BULLETIN

NUMBER 165

SUBJECT: Aileron Hinge Reinforcing Bracket,
Part Number 10931-02

MODELS AFFECTED: J-3, PA-11, PA-15, PA-16, PA-17, L-18B
and L-4 Series

AILERON HINGE REINFORCEMENT BRACKET

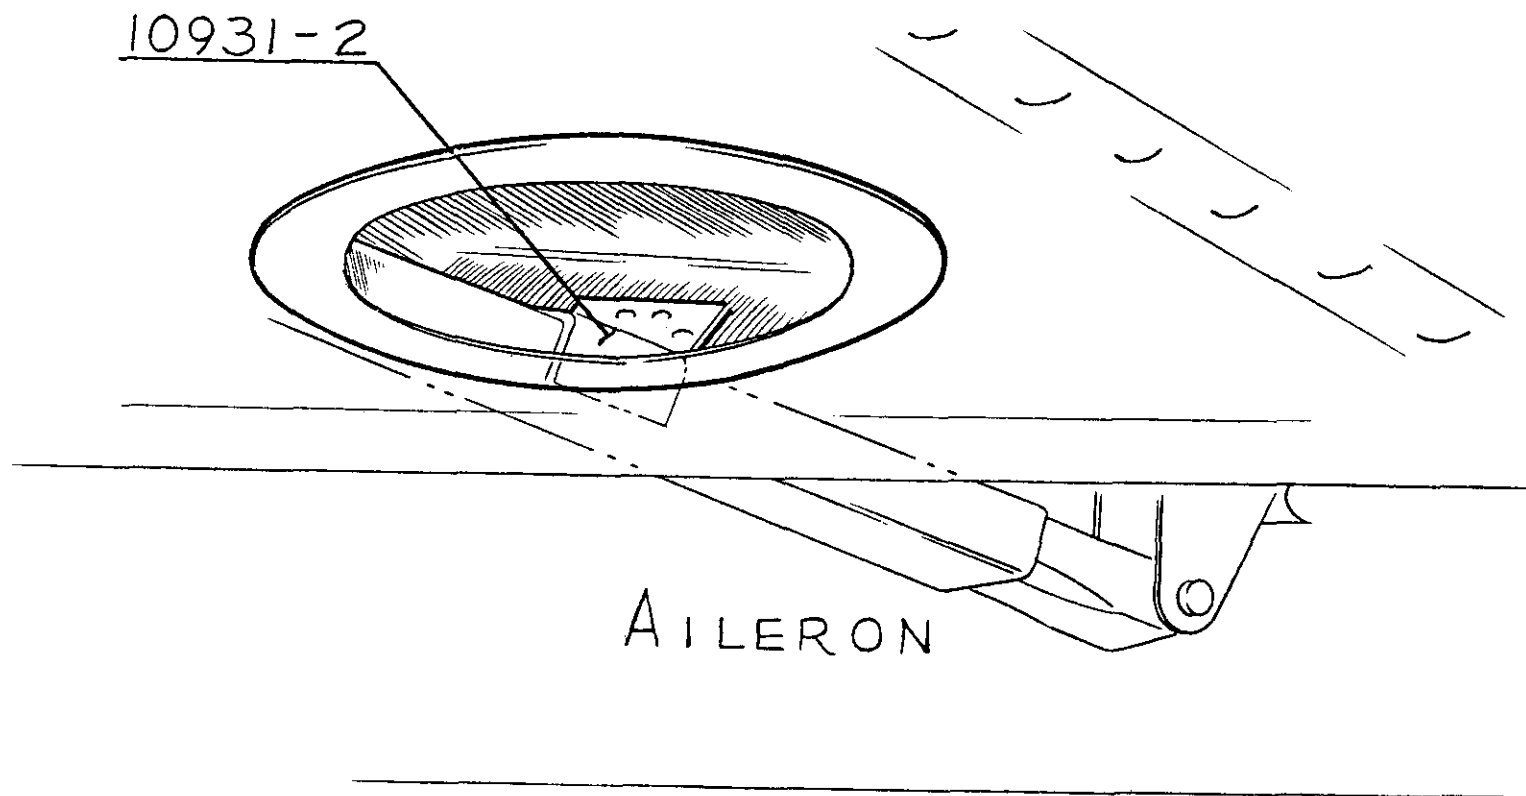
There is a possibility that a few of the subject parts have been supplied to the field during the past three years which were fabricated from aluminum instead of steel. It is requested that the subject brackets on the above mentioned airplanes, which have been replaced since June 1954, be checked to determine the type of material used to make this part. All brackets of aluminum construction must be removed and replaced with a steel bracket, part number 10931-02, which is available through your Piper distributor free of charge.

Please refer to the sketch on the reverse side of this bulletin for the location and identification of the subject bracket.
